Title:	Recommendation to Approve a PUD Preliminary Site Plan, Engineering Plan and Final Plat of Subdivision for The Quad St. Charles (Charlestowne Mall PUD)
Presenter:	Russell Colby

RE: The Quad St. Charles (Charlestowne Mall PUD) – Site Plan, Preliminary Engineering Plan and Final Plat of Subdivision for Theater Building

DATE: April 2, 2014

Approved Concept Site Plan with locations of changes:

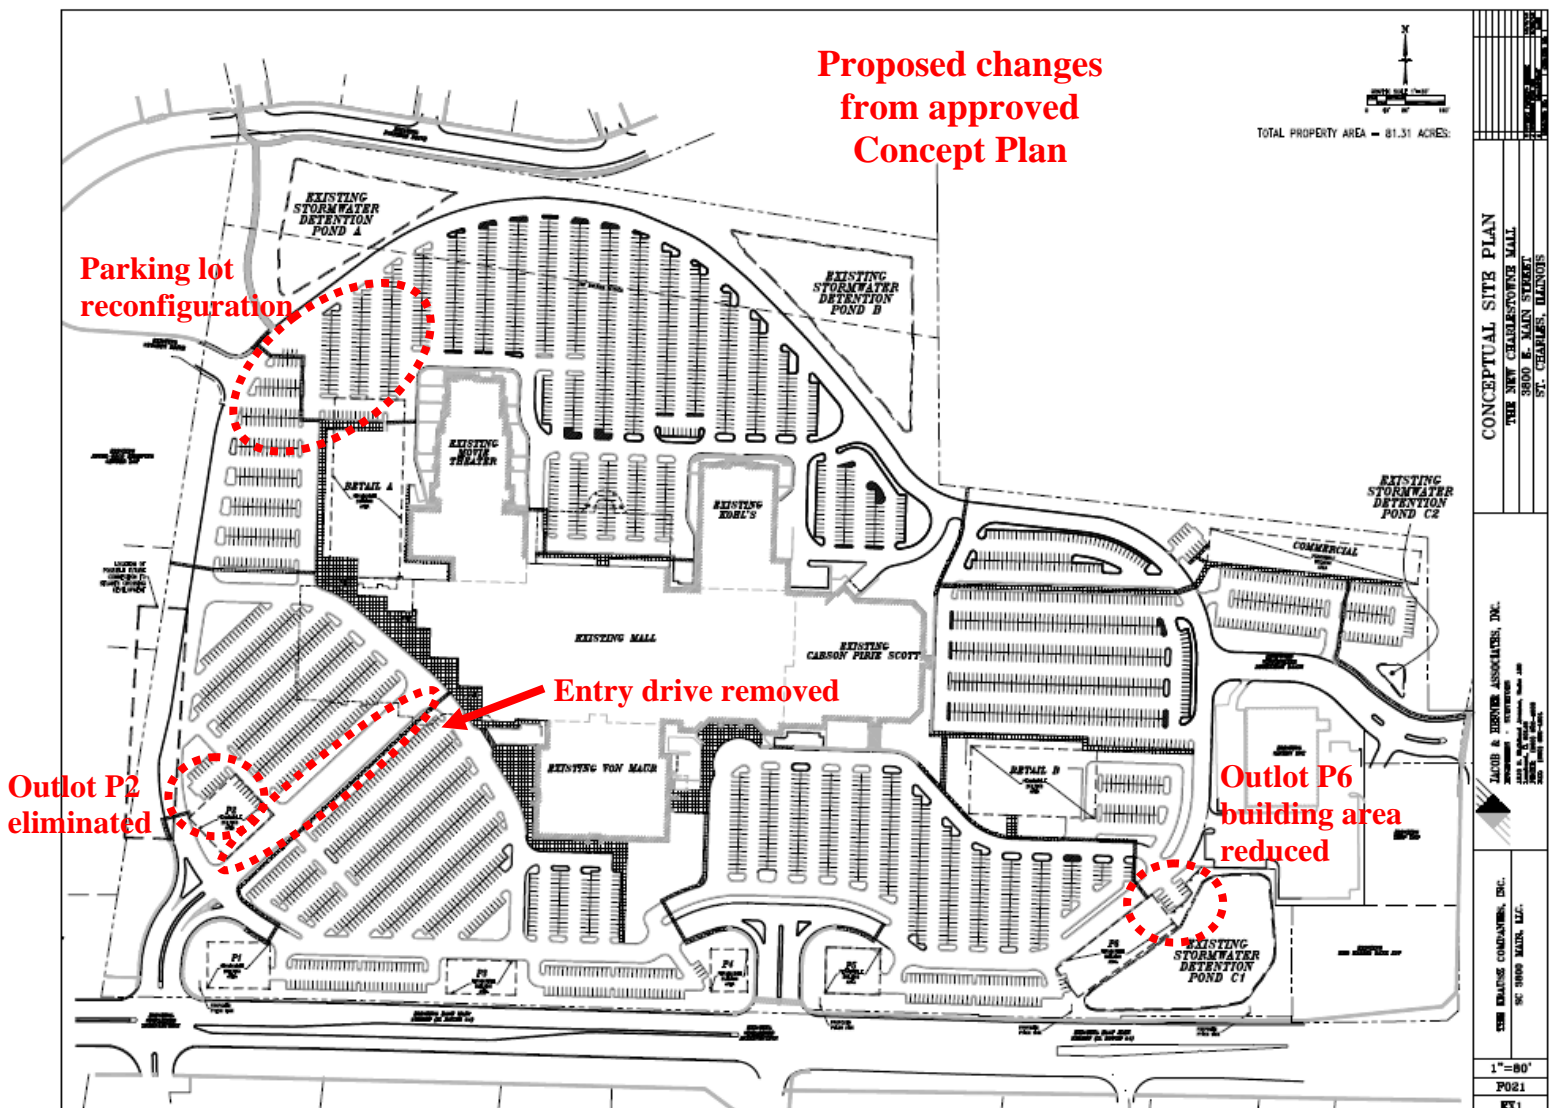
The overall site layout is substantially similar to the Concept Site Plan that was approved with the PUD ordinance. Changes to the site plan:

- Outlot building footprints and parking lots have been omitted from this plan, as these will be reviewed and approved later.
- Outlot building site P2, which was located inside the ring road at the southwest corner of the property, has been removed.
- The entry drive from the southwest entrance/ring road intersection to the mall building has been removed.
- Some areas of the parking lot have been slightly reconfigured.
- The permissible building area identified for outlot P6 adjacent to pond C1 has been reduced.
